### MILWAUKIE PLANNING COMMISSION Tuesday, October 13, 2015, 6:30 PM

- 5.0 **Public Hearings** – Public hearings will follow the procedure listed on reverse
  - 5.1 Summary: Riverway Ln Pool/Slope Project  
Applicant/Owner: Gary Klein  
Address: 10795 SE Riverway Ln  
File: NR-2015-003  
Staff: Brett Kelter

**To:** Planning Commission

HemmiGlobal Partner  
 806 SW 380 Ave., Suite 300  
 Portland, OR 97204  
 Phone: (503) 287-6825  
 Fax: (503) 415-2304  
 www.otak.com  
 17347  
 Project No. Drawing No.  
**Figure 2**  
 Sheet No.  
 © 2014 Otak, Inc.

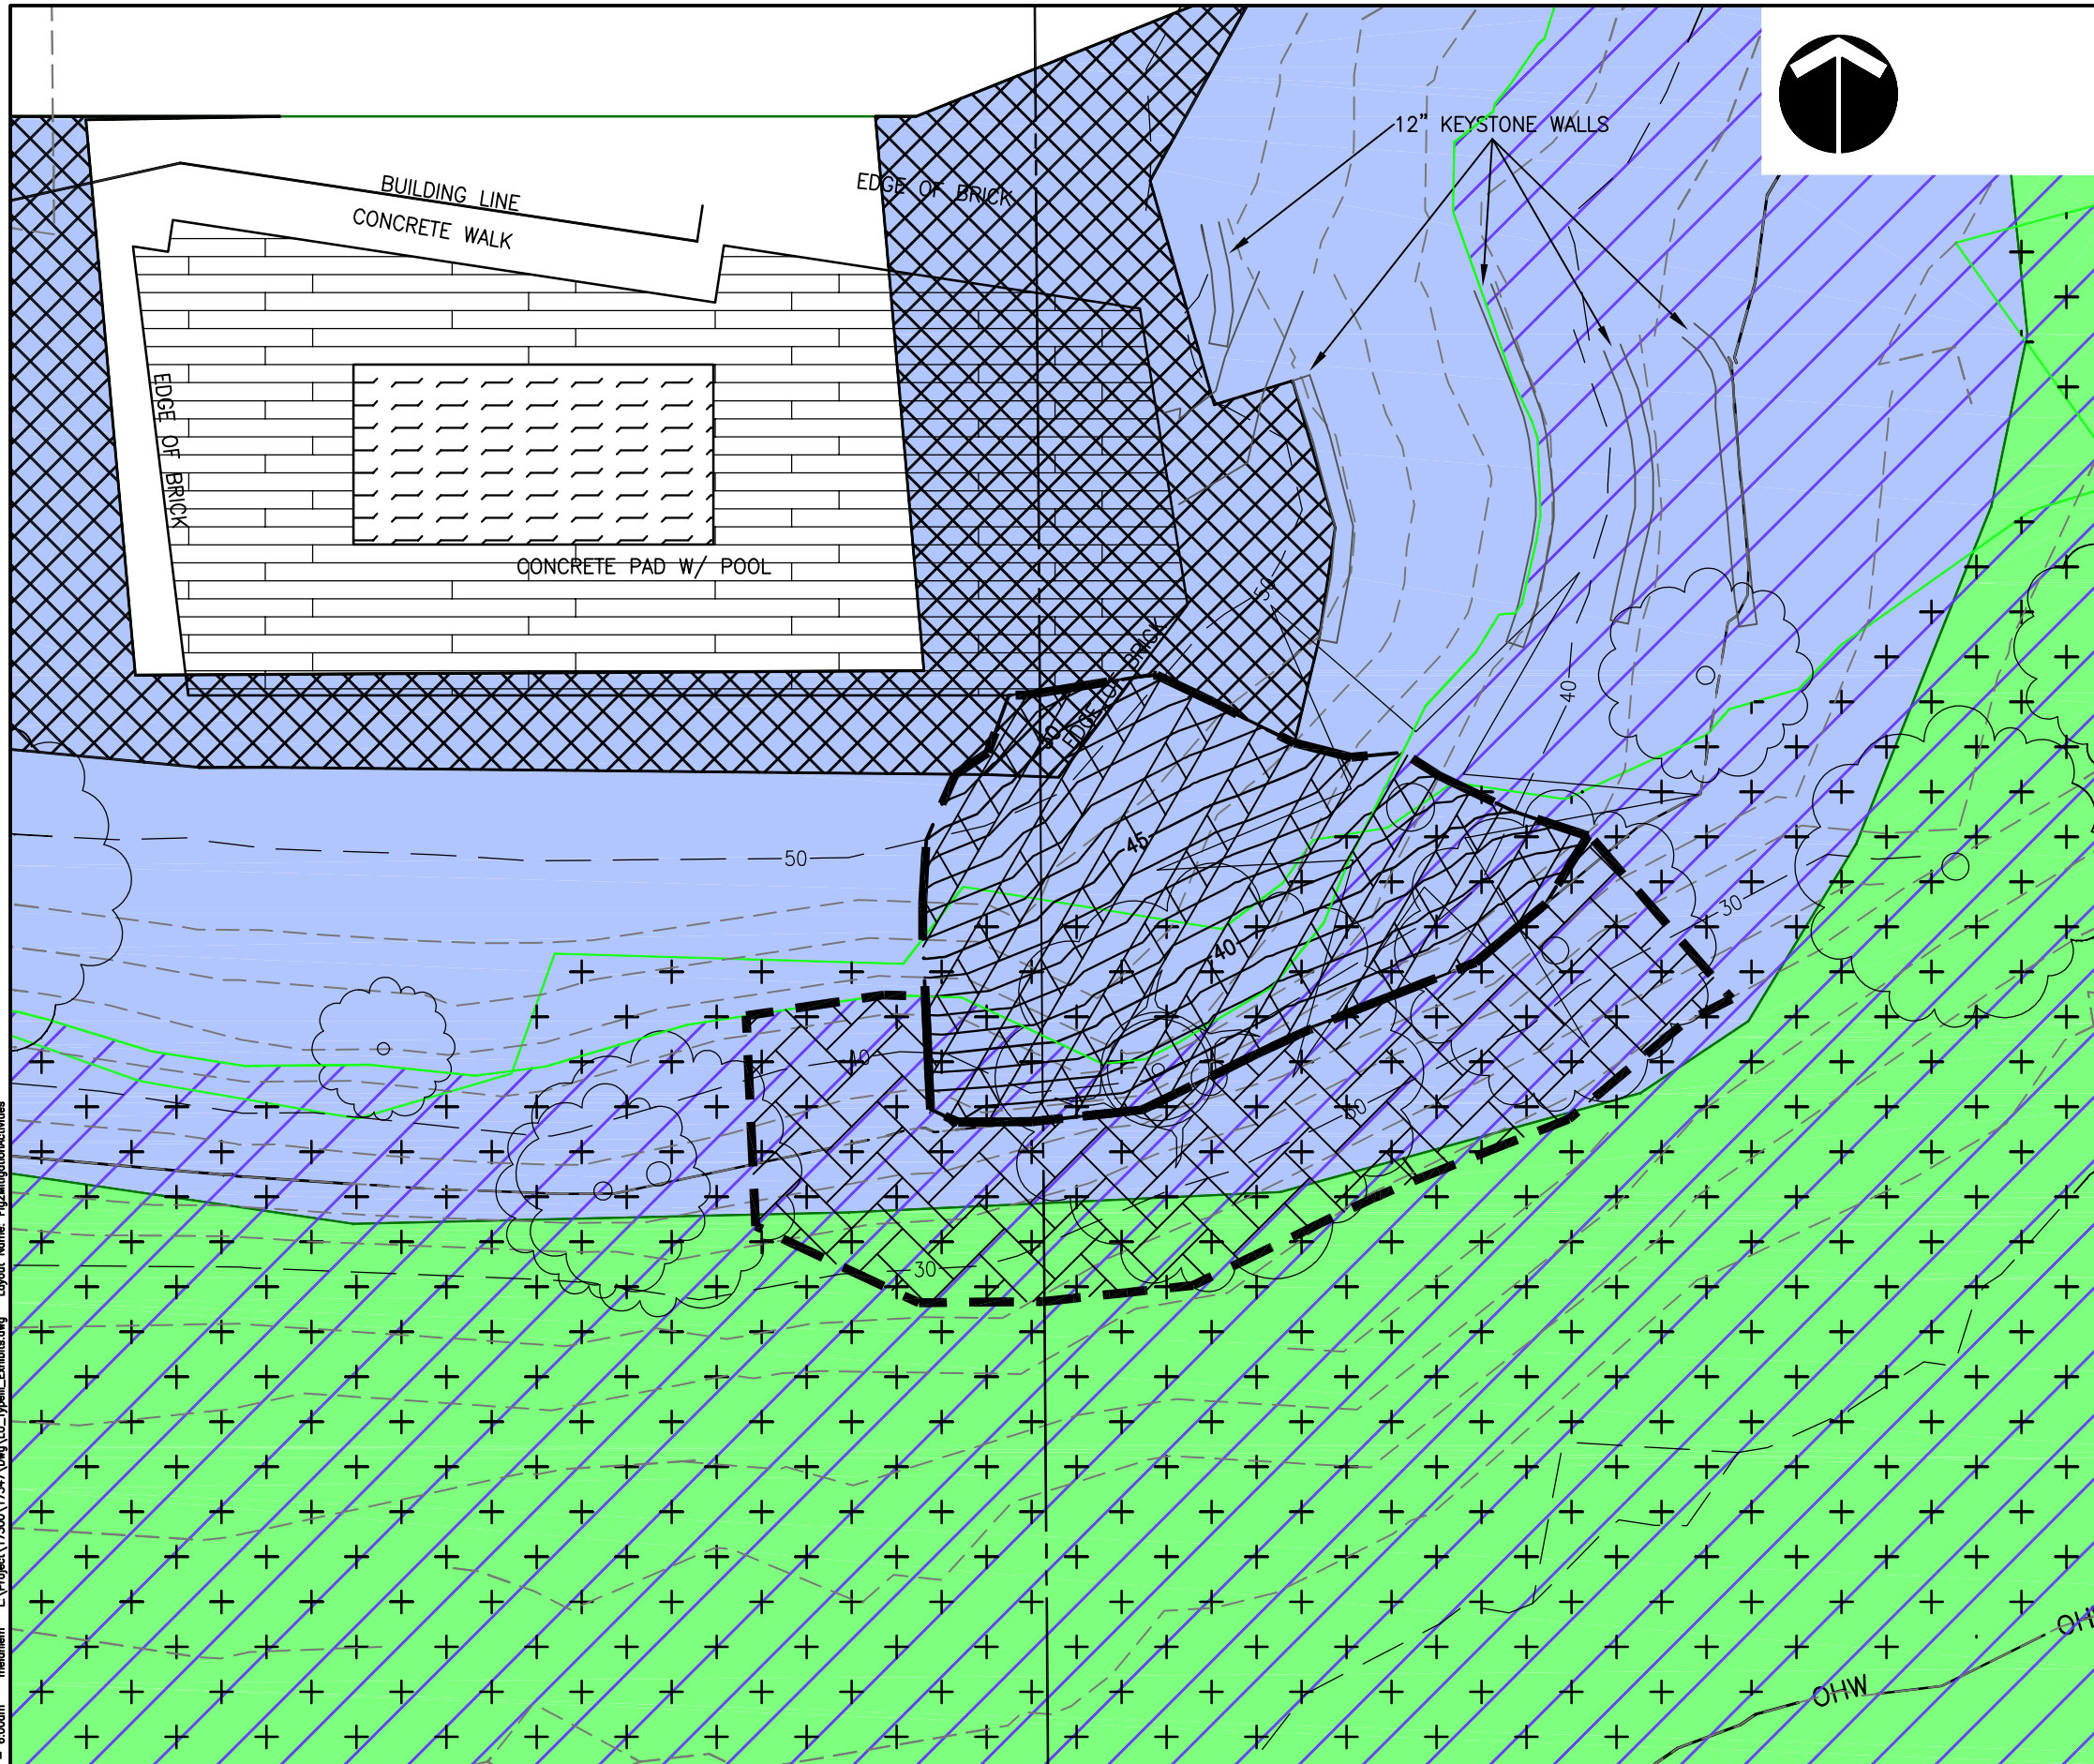
- (7) Mitigation Activities (Figure 2 in Mitigation Plan)
  - (8) Construction Management Plan (Figure 1)
- e. Based on the revised site plans noted in Condition 1-d, provide an adjusted figure for WQR and HCA disturbance and a recalculation of mitigation plantings, at the ratio of 5 trees and 25 shrubs per 500 sq ft of disturbance.
